ADDENDUM NO. 1

**Citywide Adaptive Signal Control System – ITS Improvements – Phase 1 & 2 and Phase 3
RFB # 19-011**

TTC22

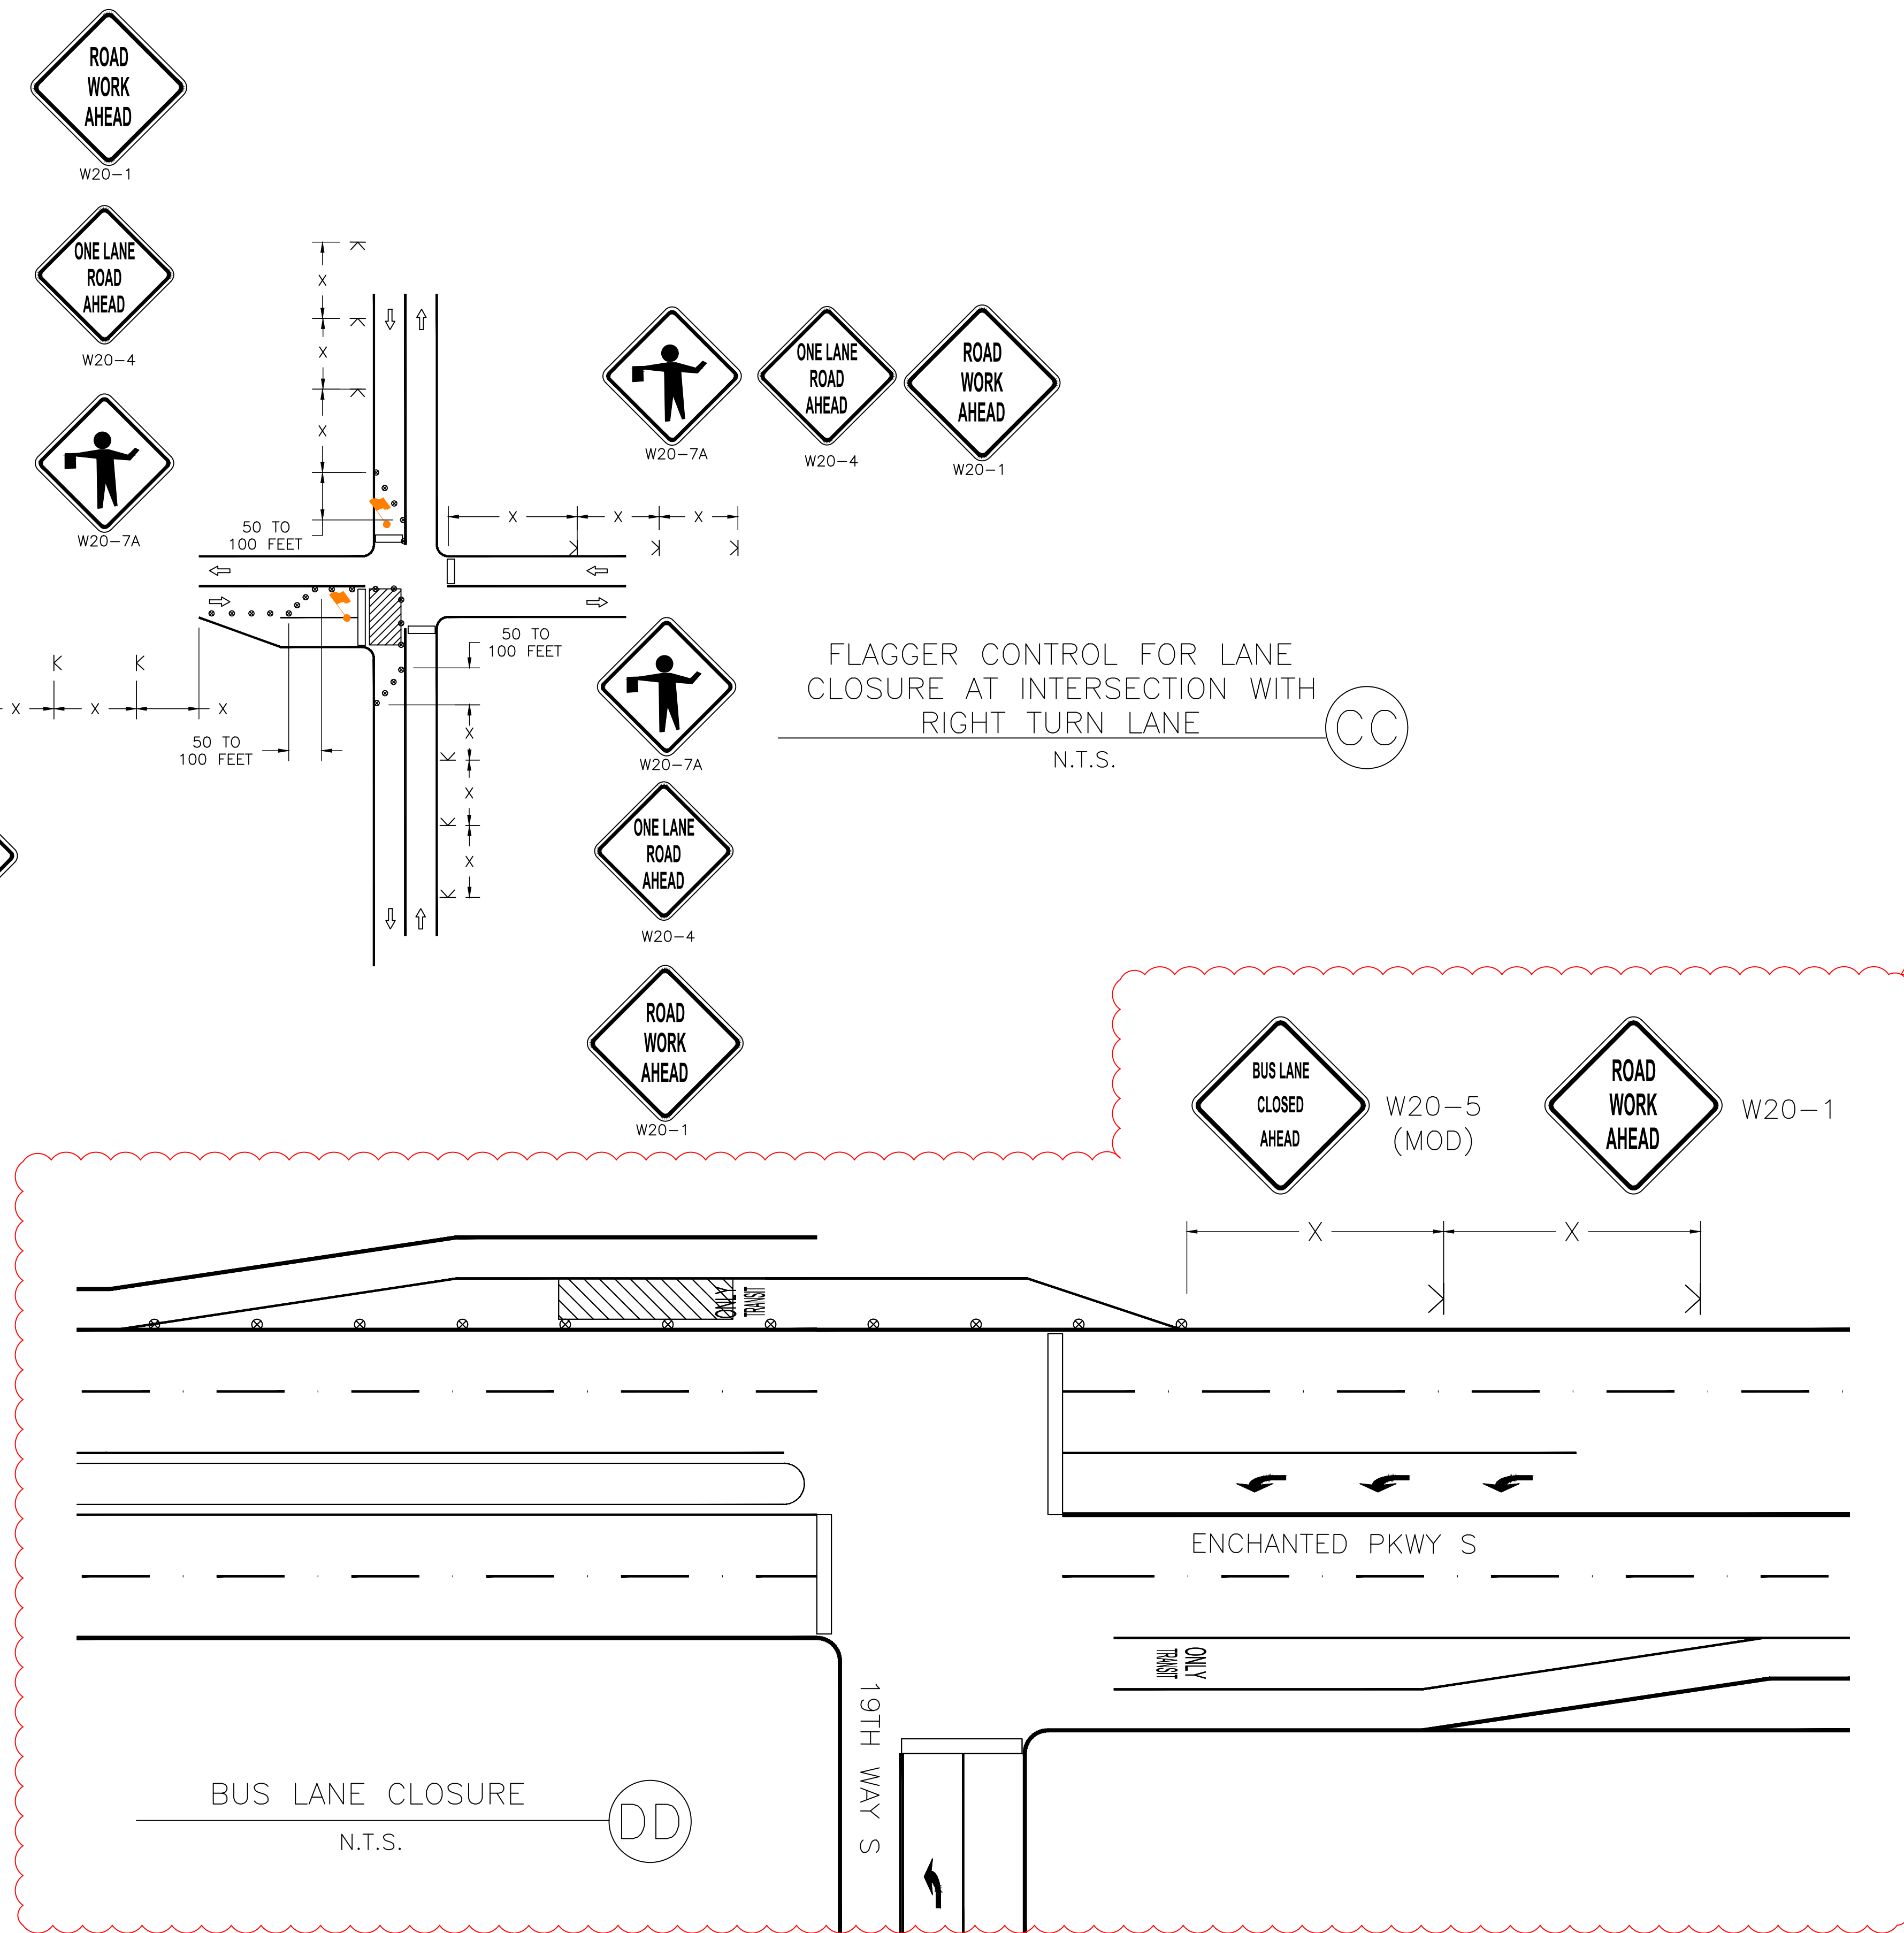
DELETE this sheet and REPLACE with the attached revised Sheet TTC1.

This change provides additional details regarding the temporary traffic control for sheet ITS44.
